Maintenance Advisory

MA 2024-02

CAT-350 Guardrail Terminal: Addition of Square Post Bolt Washers

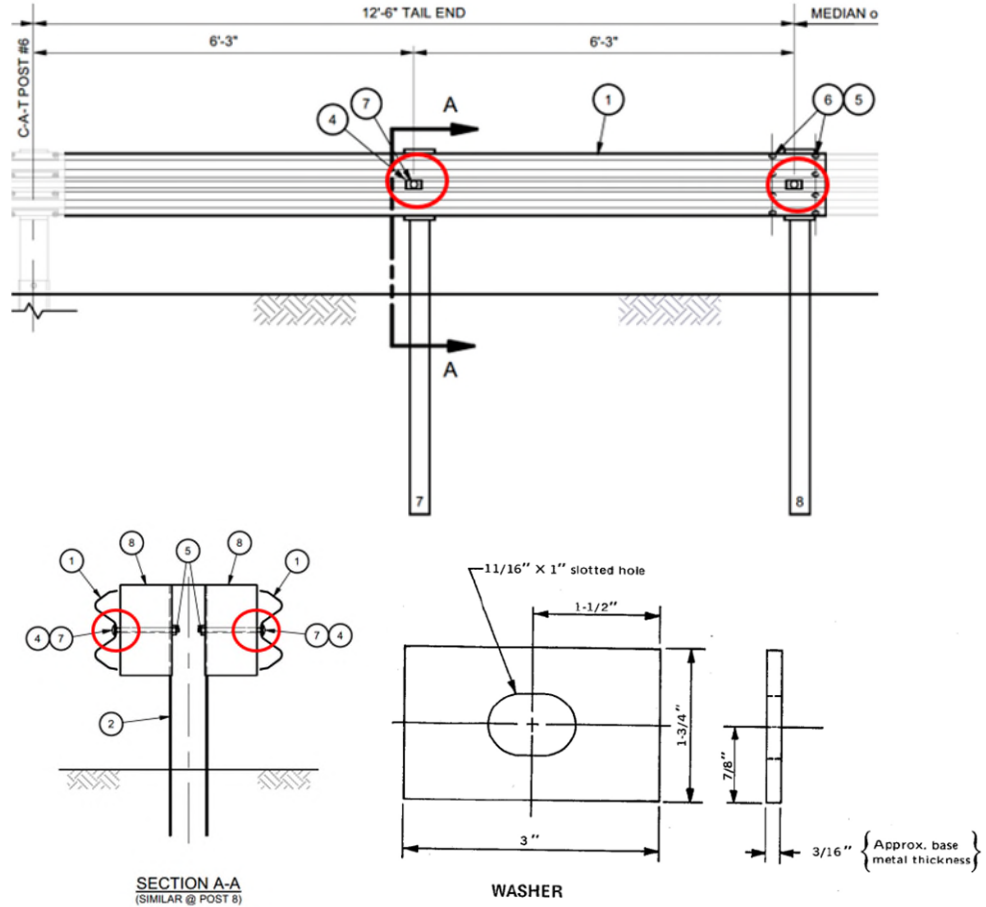
Maintenance forces are being asked to identify existing CAT-350 terminals along roadways within existing closures and/or undergoing routine maintenance activities and determine if rectangular post bolt washers are present at posts #7 and #8 of the terminal. If rectangular washers are not present, install rectangular washers at posts #7 and #8 as prescribed herein. Additional hardware, besides the rectangular washers, should not be required in cases where the existing hardware is in good condition. However, additional hardware may be required if the existing hardware is damaged and/or in poor condition.

Posts #7 and #8 represent the seventh and eighth posts downstream of post #1, which is the first post of the terminal (refer to picture below).

A rectangular washer is required on each side of posts #7 and #8. Therefore, a total of four rectangular washers are required per terminal (rectangular washers circled below).

Each rectangular washer consists of a 3/16" x 1.75" x 3" galvanized steel washer. These are the same washers that were used in guardrail installations from the 1980s and earlier.
